Environmental Review Team Report

Merrick Brook Estates

Hampton, Connecticut

January 1982

Surficial Geology

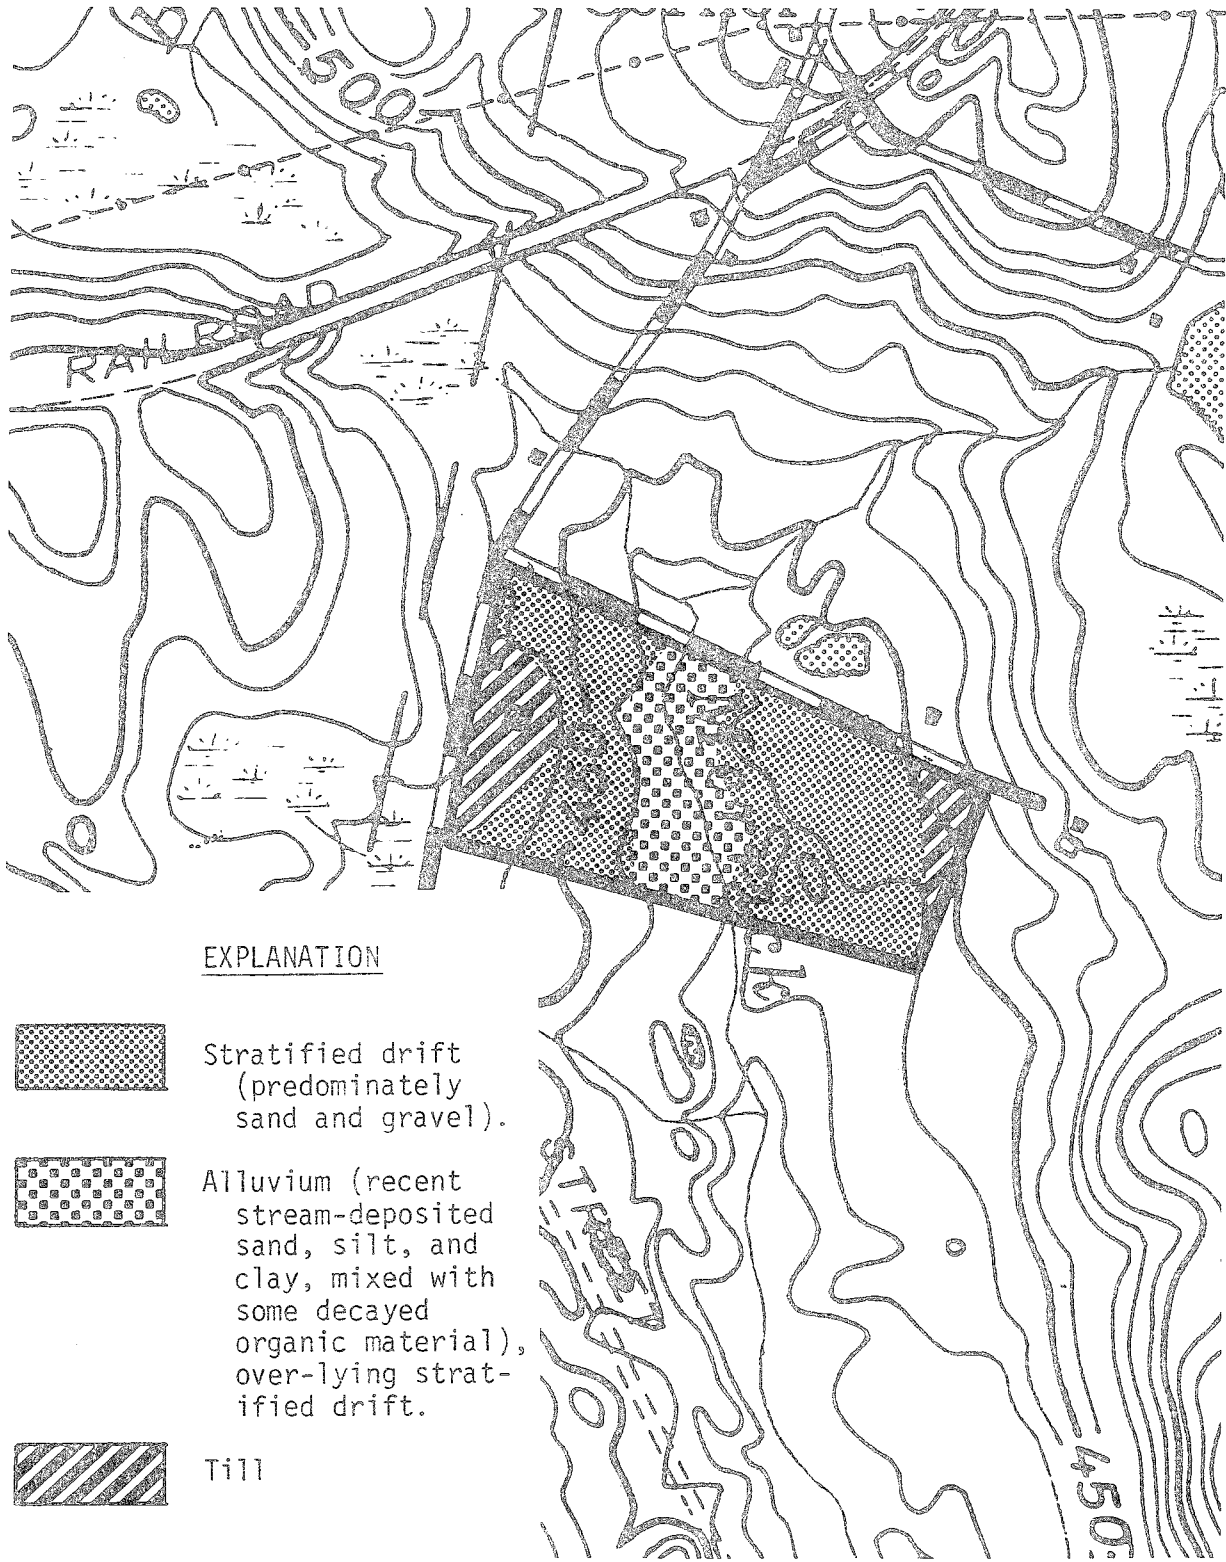
Most of the site is covered with coarse-grained stratified drift. The term "stratified drift" refers to glacial sediments that were deposited by meltwater. Meltwater streams flowed rapidly away from wasting masses of glacier ice, carrying fine-grained particles further away than the coarser materials, and thereby sorting the sediment. As a result, the stratified drift on the site consists predominantly of sand and gravel. Test pits on the site indicated that gravel was at least seven feet deep in Lots 2 through 7. Records made by the test-pit excavator also show gravel to seven feet for "Lot 10," but it is not clear whether this was the same lot as the presently proposed Lot 10.

Several wet basins are located in the rear portions of Lots 1 through 4. These basins appear to be places where gravel was excavated to just below the water table. It is possible, however, that one or more of the basins are natural.

Floodprone Area

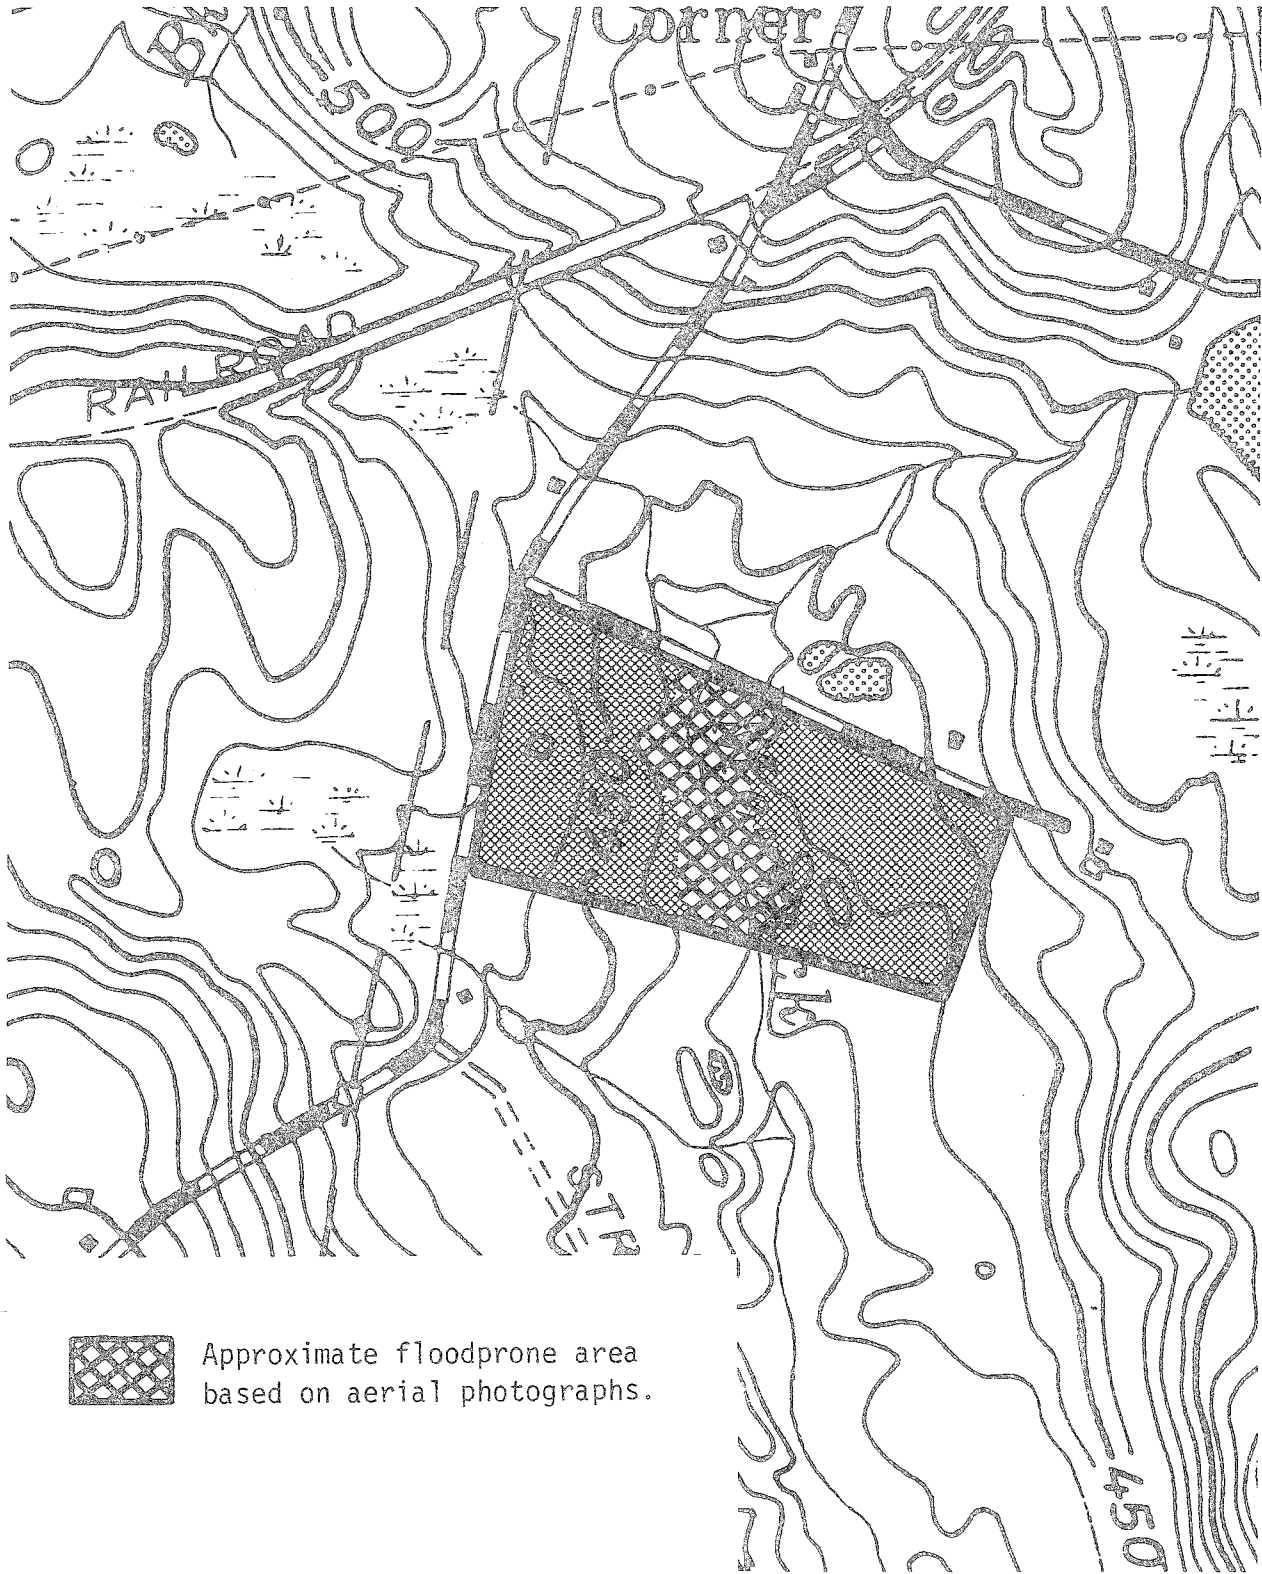
than the U.S.G.S. topographic information) would allow one to estimate the 100-year floodplain of Merrick Brook. The Team has included in this report an estimate of the flood-prone area based on an analysis of aerial photographs. The limitations of this estimate should be recognized.

Despite these limitations, it seems safe to conclude that most of the frontage portions of Lots 5 and 6, part of the rear portion of Lot 5, and the eastern portion of Lot 11 would be subject to flooding on a periodic, though perhaps infrequent, basis. It would, of course, be possible to fill part of the flood-prone area in order to elevate the houses and septic systems above the flood level, but filling in floodplains is not a wise idea, since it can aggravate flooding problems in other areas. Lots 5 and 11 may have enough area outside the flood-prone boundaries to locate a house and septic system. Lot 6 may not have even enough non-flood-prone area for a septic system.

Vegetation

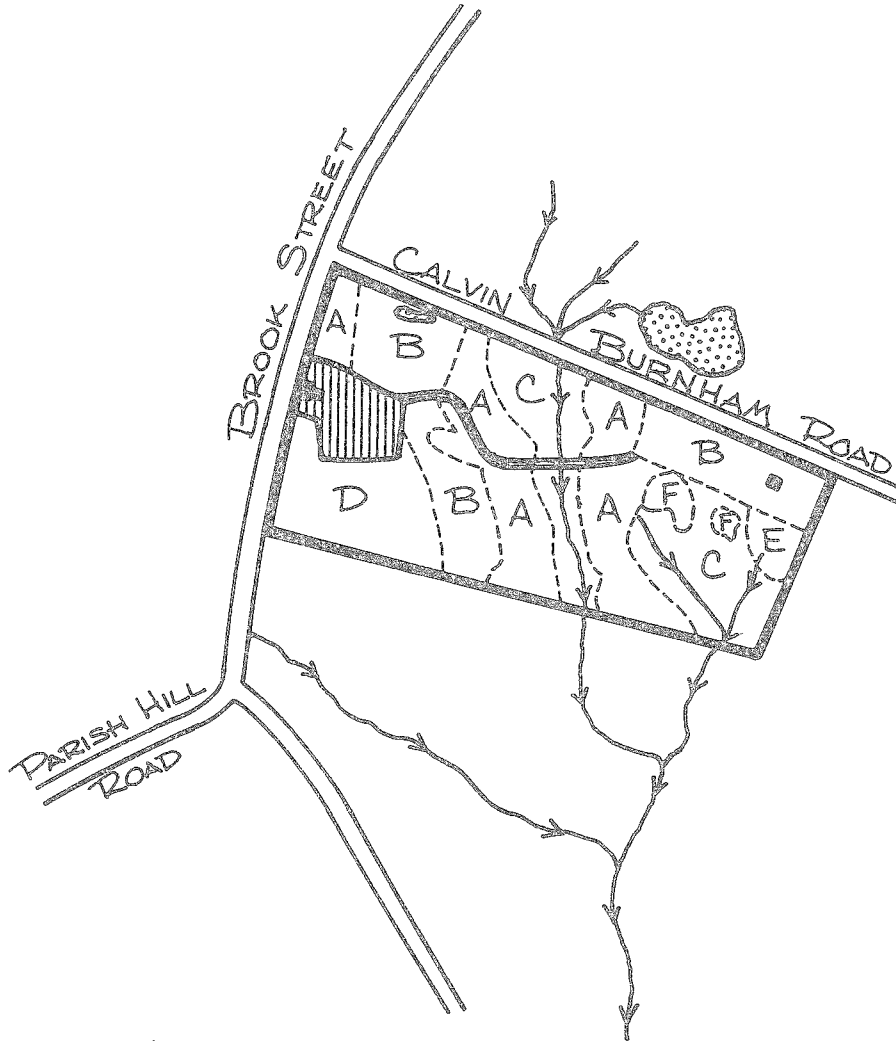
Care should be taken during the construction period not to disturb the trees that are to be retained for their aesthetic value. In general, healthy and high vigor trees should be favored for retention because they are usually more resistant to the environmental stresses brought about by construction.

Trees are very sensitive to the condition of the soil within the entire area under their crowns. The variable topography which is present within parts of Lots 5, 6, 7, and 11 may necessitate excavating, filling and grading for the construction of driveways, septic systems and buildings. These practices may disturb the balance between soil aeration, soil moisture level and soil composition. These disturbances may also cause a decline in tree health and vigor, potentially resulting in tree mortality within three to five years. Mechanical injury to trees may cause the same results. Dead trees reduce the aesthetic quality of an area and may become hazardous and expensive to remove if near driveways, buildings or utility lines.

The trees which are present in Vegetation Types A and D (Mixed Hardwoods) and parts of Vegetation Type C (Hardwood Swamp) are declining in health and vigor as a result of their crowded condition. Periodic fuelwood thinnings that are focused on the removal of the poorest quality trees in the overstory, up to 1/3 of the total volume in Vegetation Type A and no more than 1/4 of the total volume in Vegetation Type C, will reduce the crowded condition enough to allow the residual trees to respond over time with improved health, vigor, and stability.

To avoid irreversible soil damage, thinning operations in the hardwood swamp areas should only be implemented during the winter months when the ground is frozen or the summer months when the ground is dry.

The trees which are present within Vegetation Type D are also crowded and would respond well to the "crop tree selection method" of thinning.
